SUBJECT: Response to Peer Review by Woodard & Curran and Planning Review by City of Auburn for Bear Self-Storage & Auto Sales Facility, 828 Center Street, Auburn, ME

On behalf of Bear Holdings LLC and Bear, LLC, Wright-Pierce has prepared a response to the peer review comments by Woodard & Curran regarding the Stormwater Management Plan and the City of Auburn's planning comments for Bear Self-Storage and Auto Sales facility located at 828 Center Street.

We offer the following responses, noted in bold, to comments received in the Woodard & Curran stormwater review memo dated July 10, 2024:

DRAWING
C-4

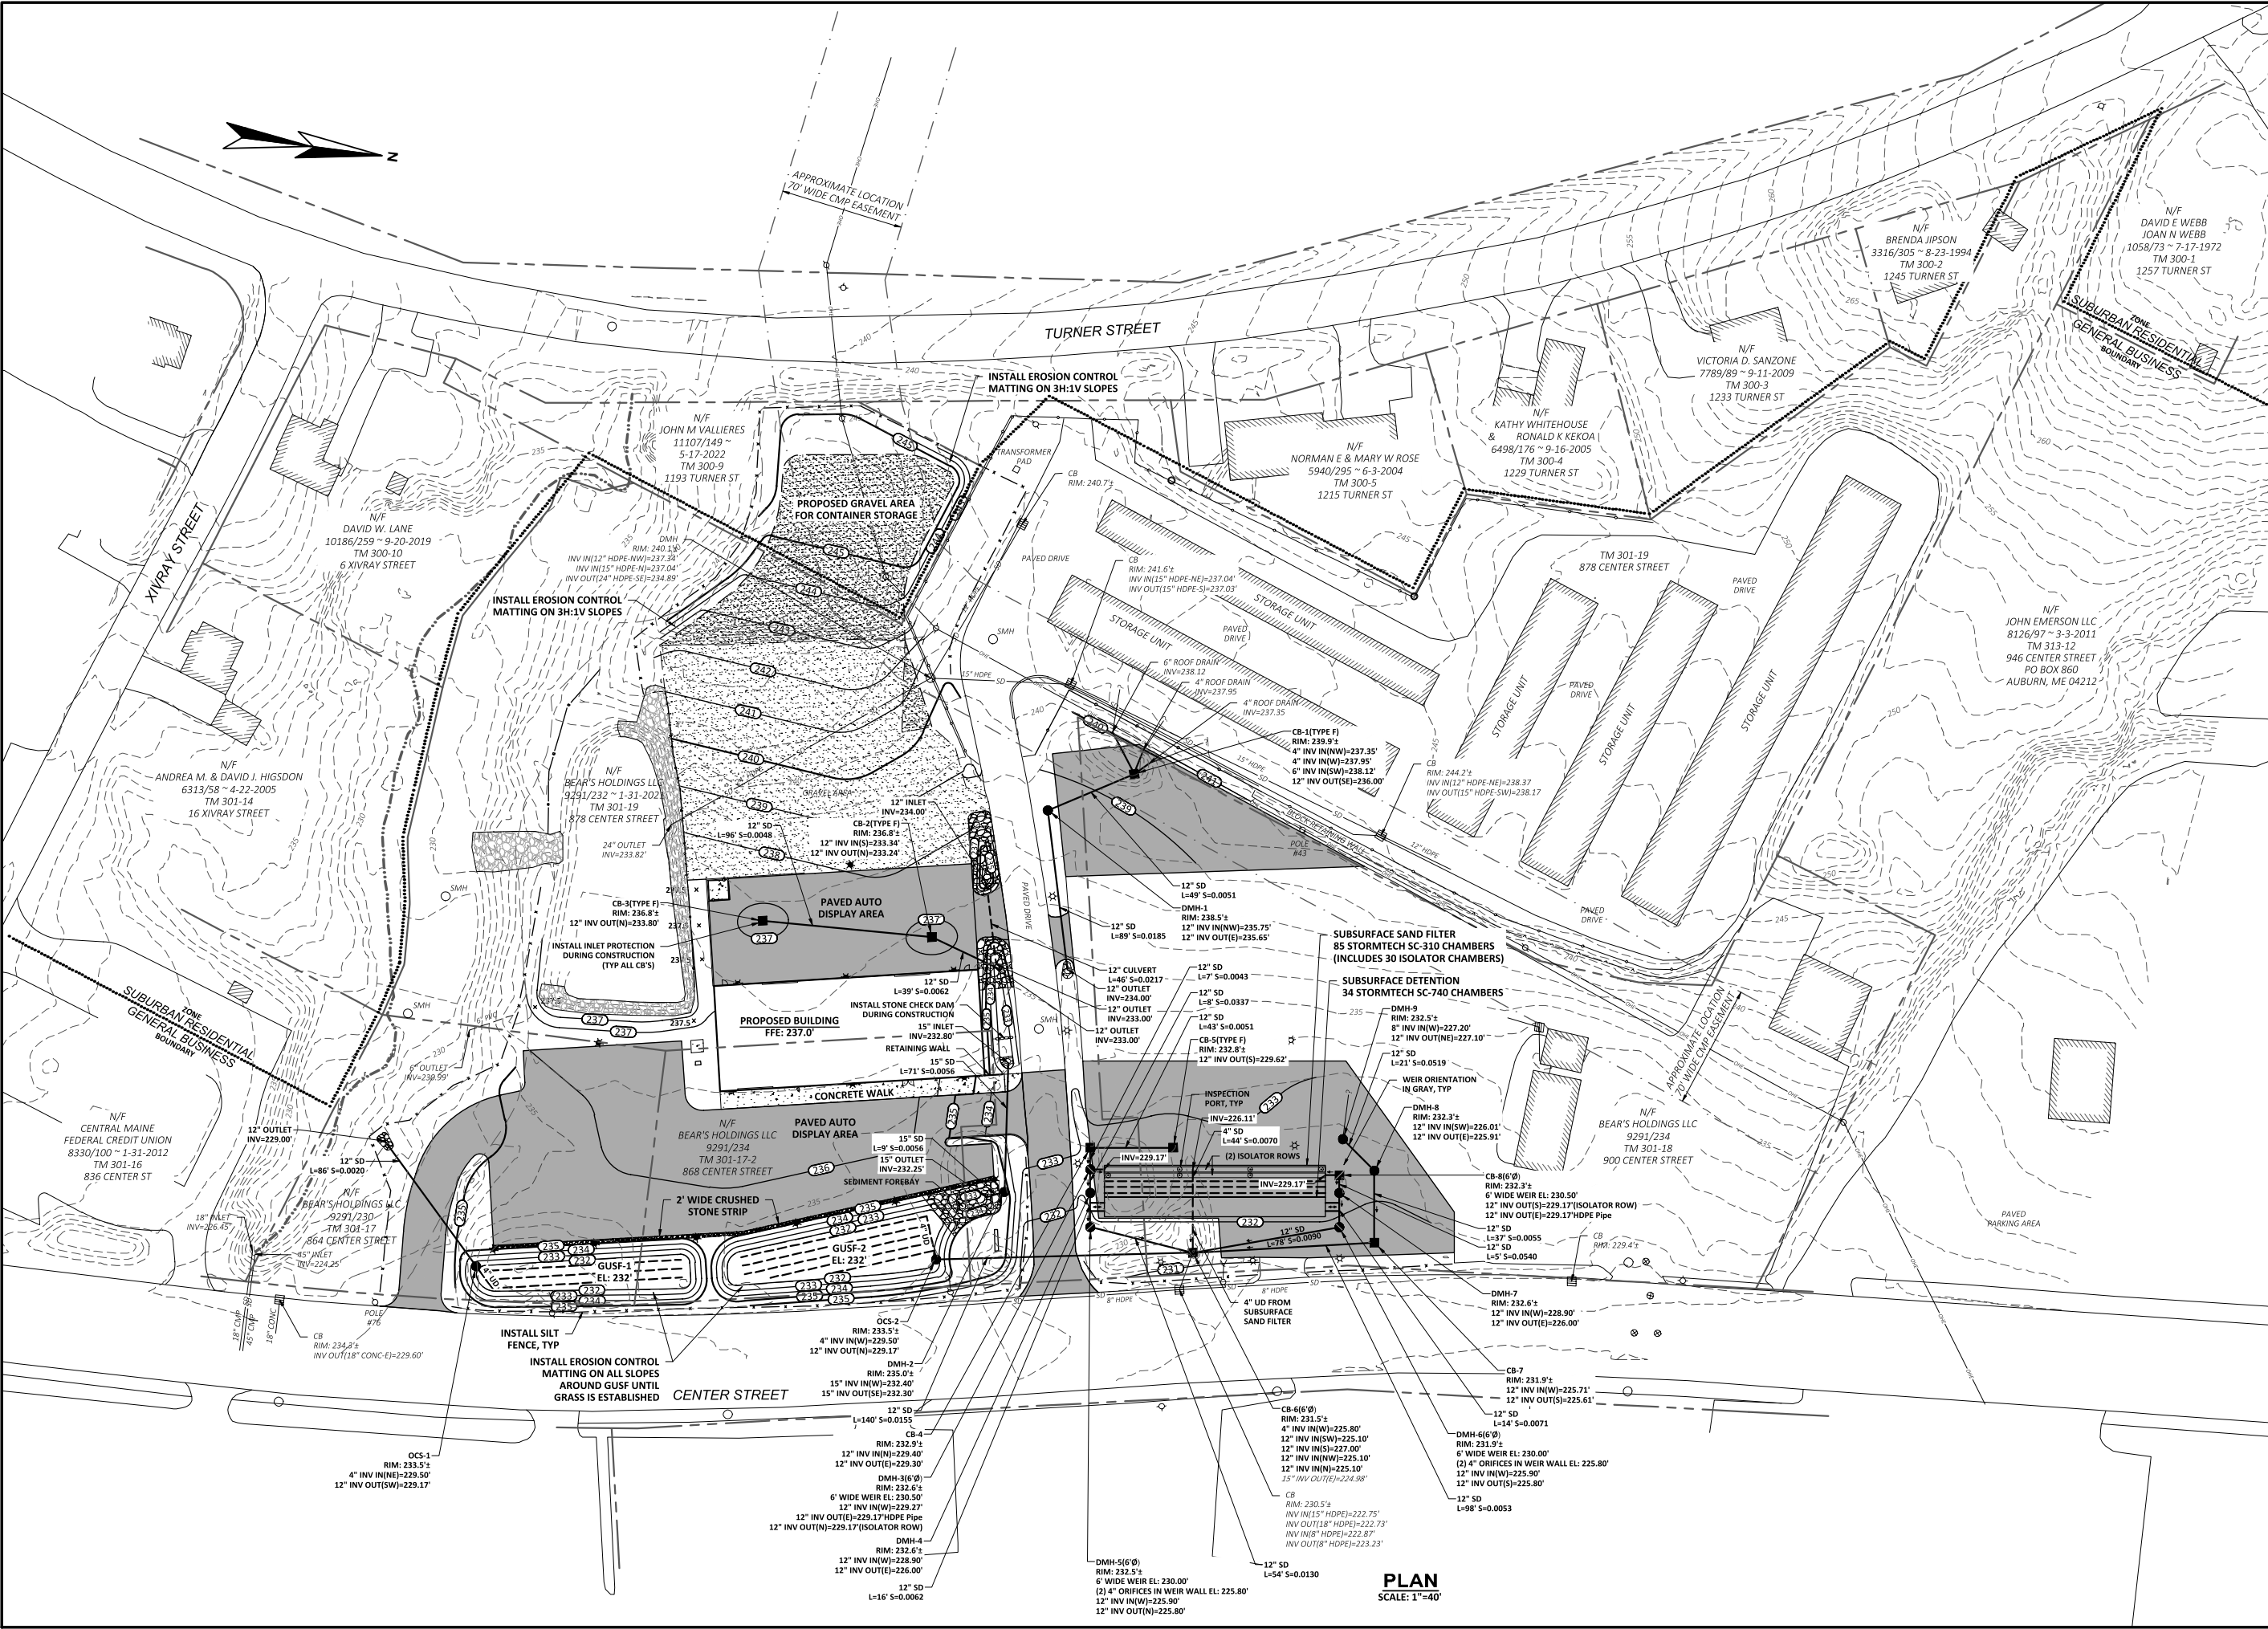
The plans do not appear to show all proposed erosion and sediment control measures. The Applicant should include erosion controls in accordance with Maine DEP Basic Standards. A written report and details have been provided, but locations of all erosion control measures should be shown on the plans in coordination with the details and notes that have been provided.

Response: Erosion control measures have been added to the grading plan (C-4). Silt fence is proposed downgradient of disturbances. Catch basin inlet protection, stone check dams, erosion control matting, etc. are noted on the plan and further instruction to the contractors is included on sheet C-10, to implement additional measures as site conditions dictate.

DRAWING
2

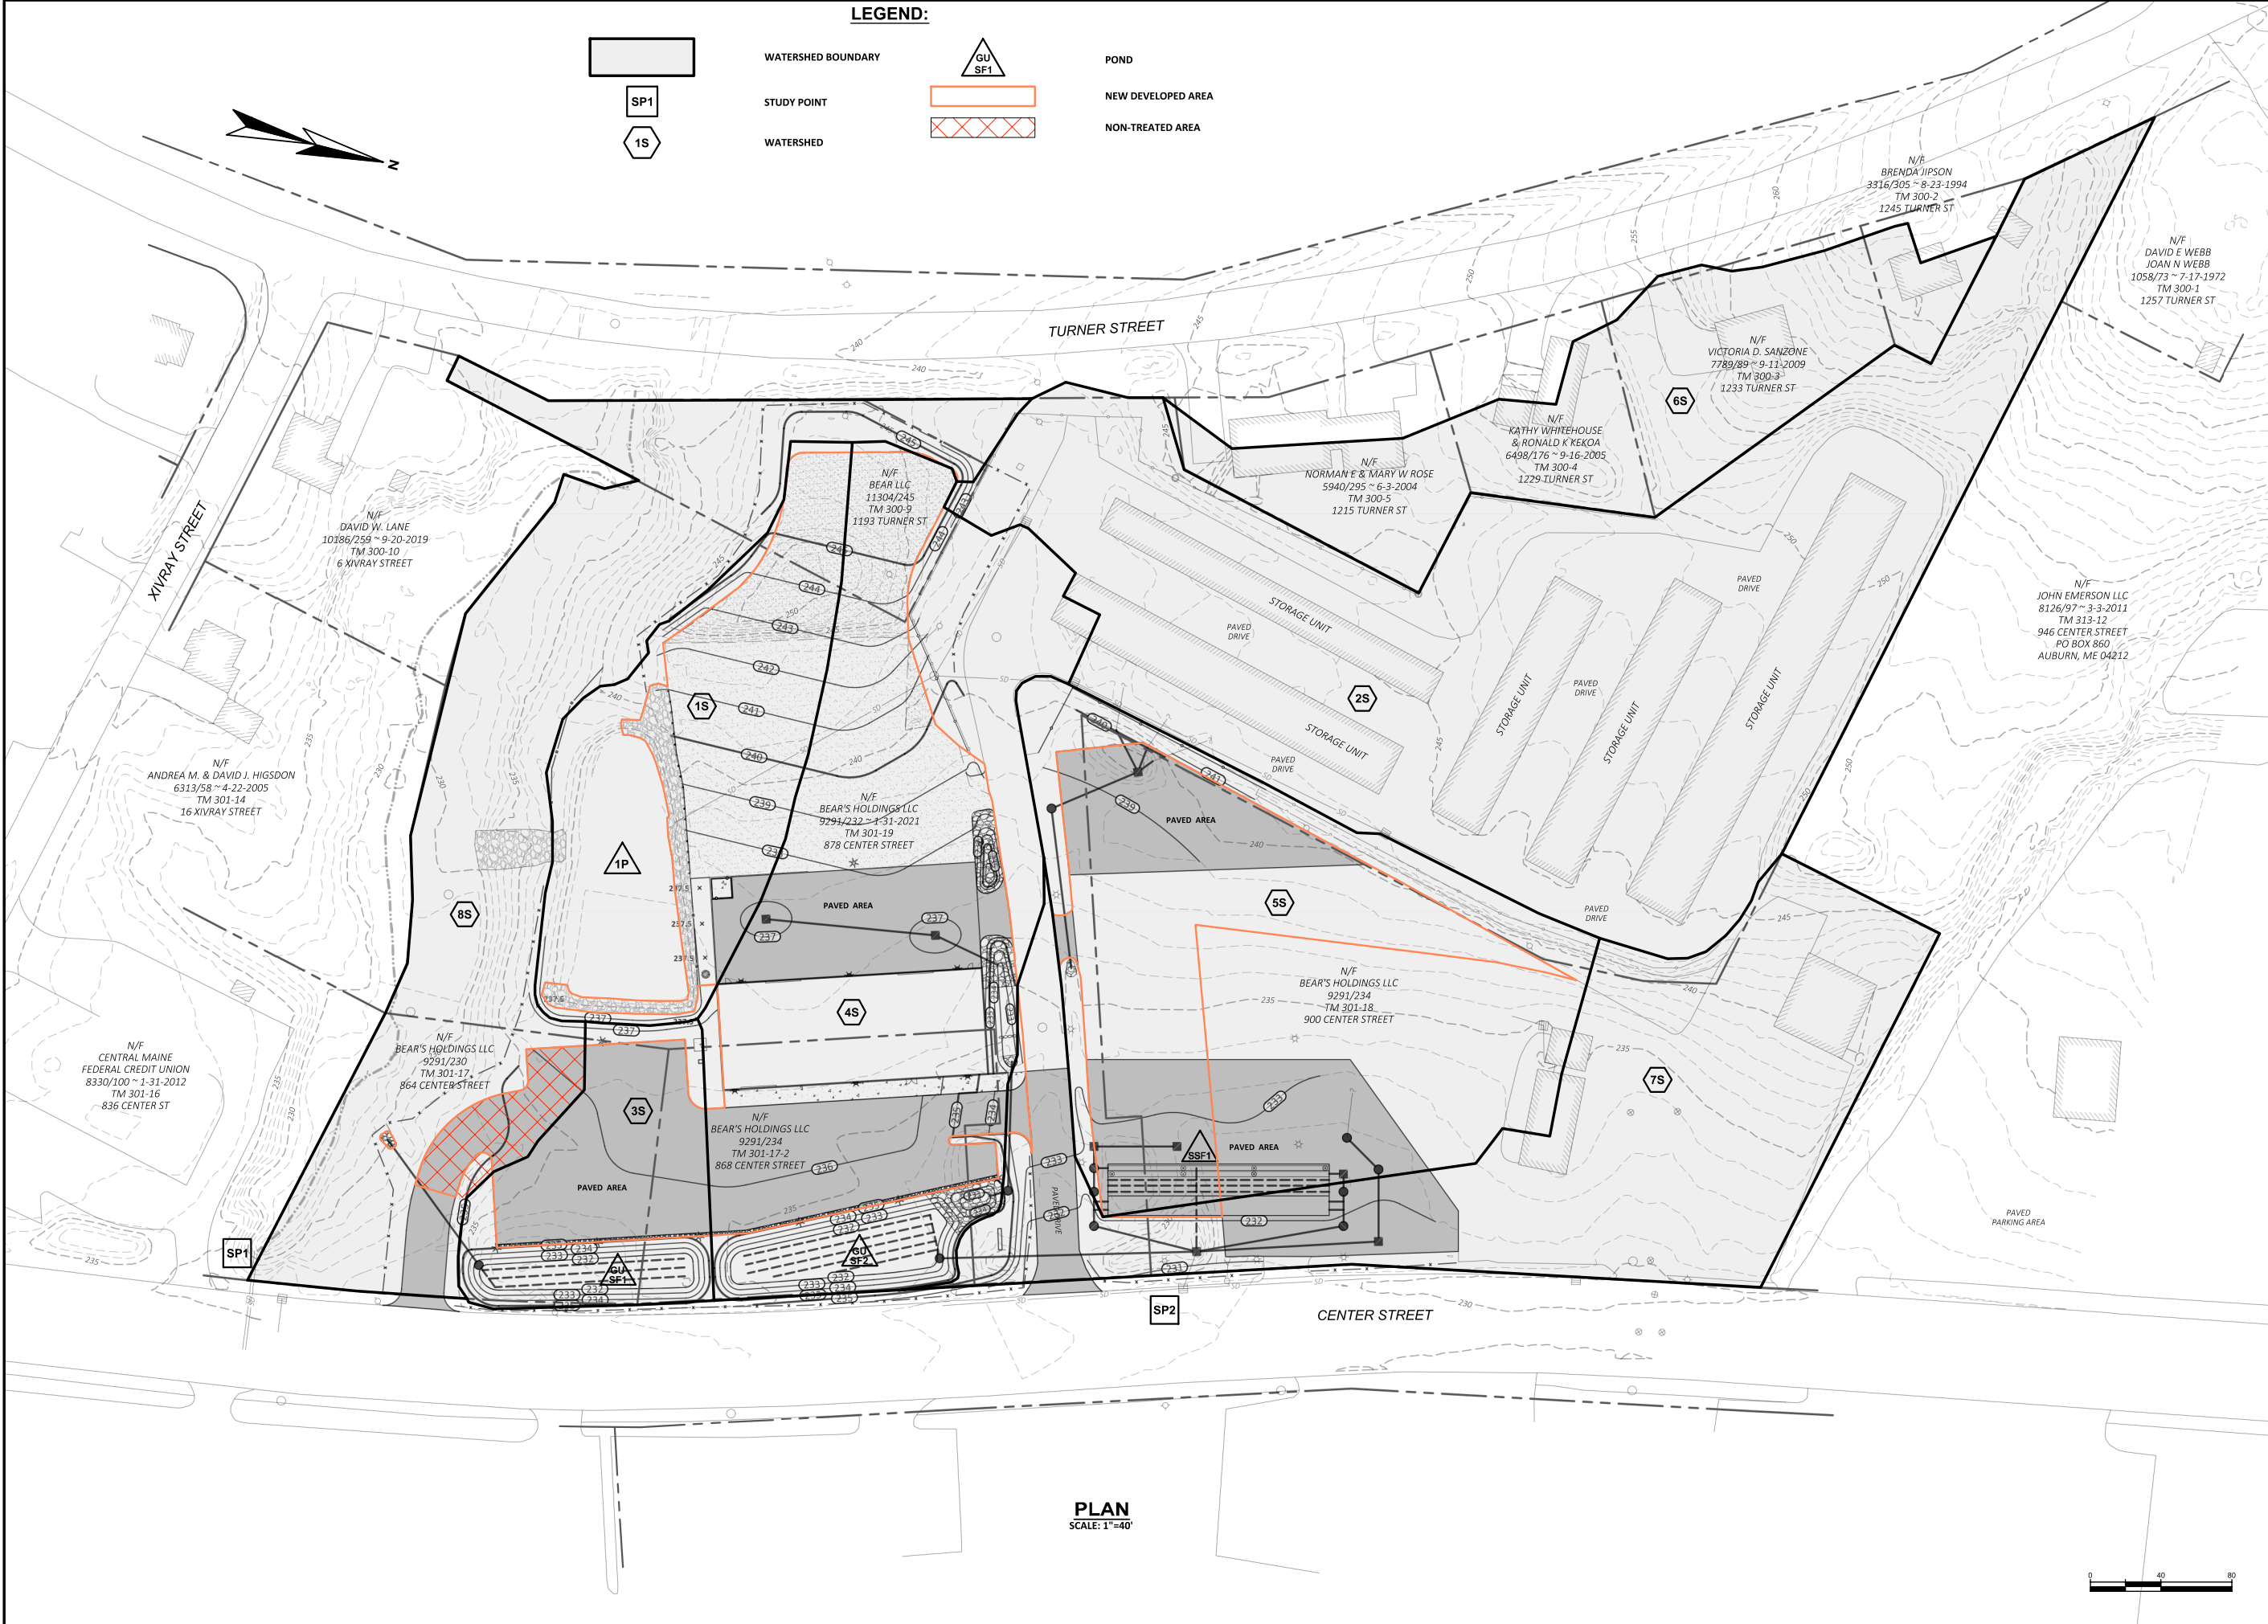
- In the HydroCAD model, subcatchments 3S and 4S are routed to GUSF1 and GUSF2, respectively. Whereas 3S appears to be routed to GUSF2 and 4S routed to GUSF1 in the Post Development Stormwater Plan. Please confirm exact routing and update for consistency.

Response: The drainage plans have been revised since the GUSFs were mislabeled. The routing in HydroCAD is correct.
